## MOD5 SSD7348

### Response to Council submission on MOD5 - SSD7348, dated 9 September 2020

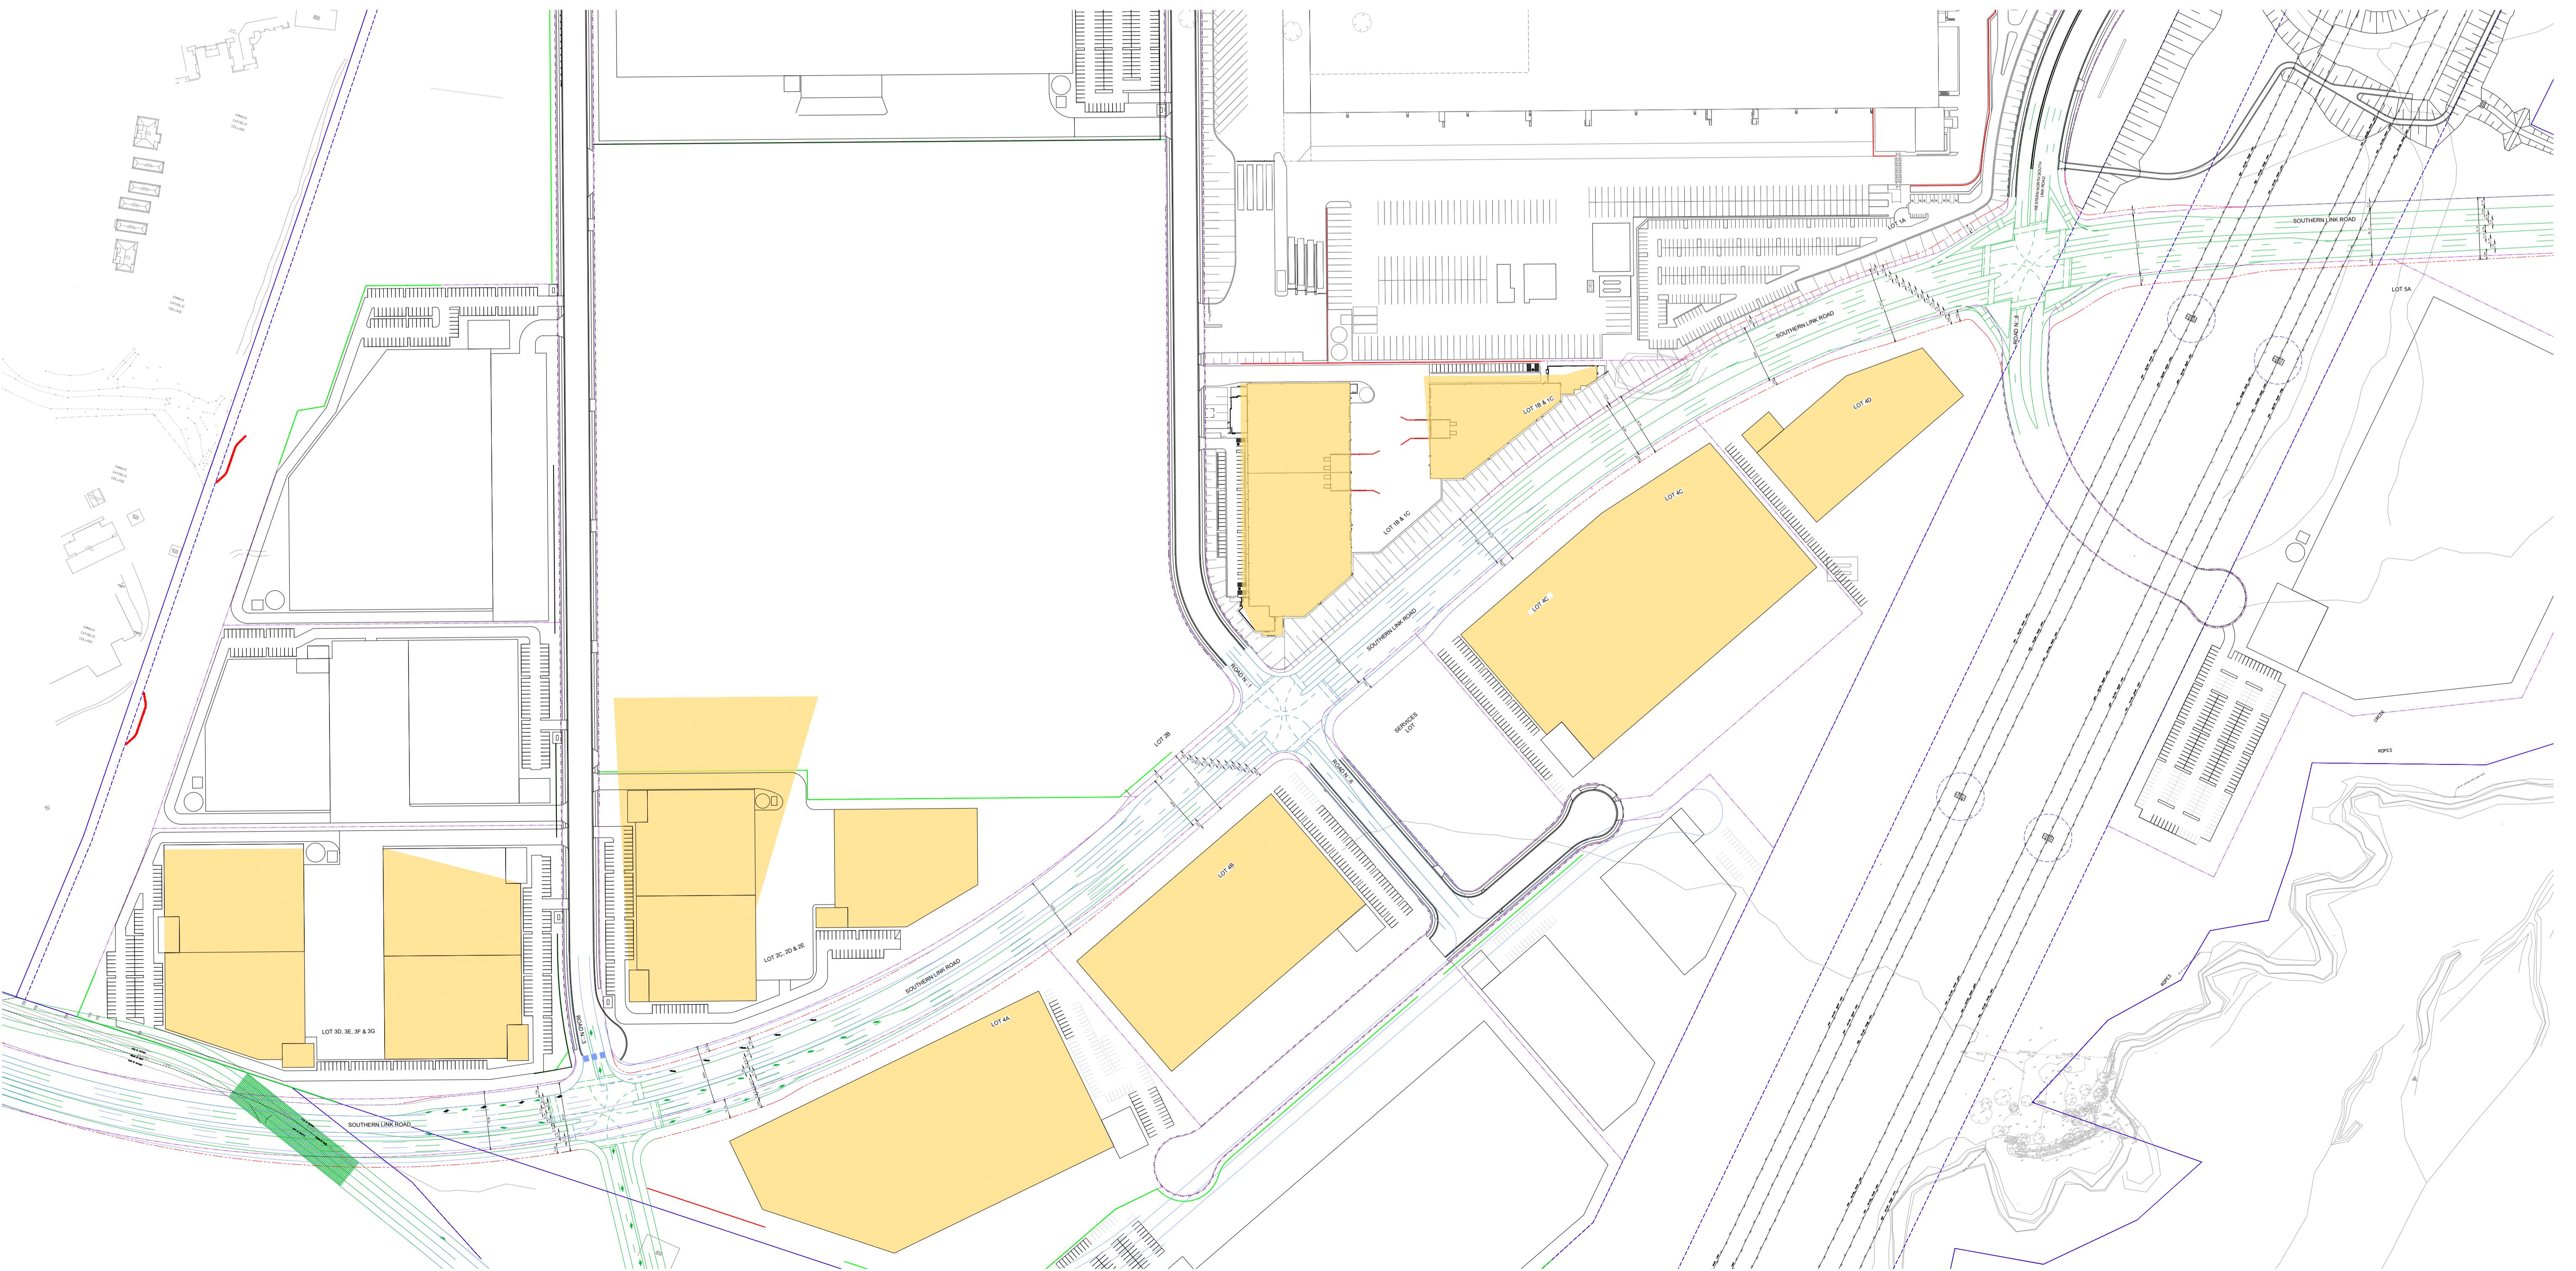
We note that Goodman has increased the SLR road corridor to 36.6m per the request of TrfNSW (refer attachment 3 and 4).

Please confirm the adjusted plan provided and discussed in our meeting last Thursday is sufficient.
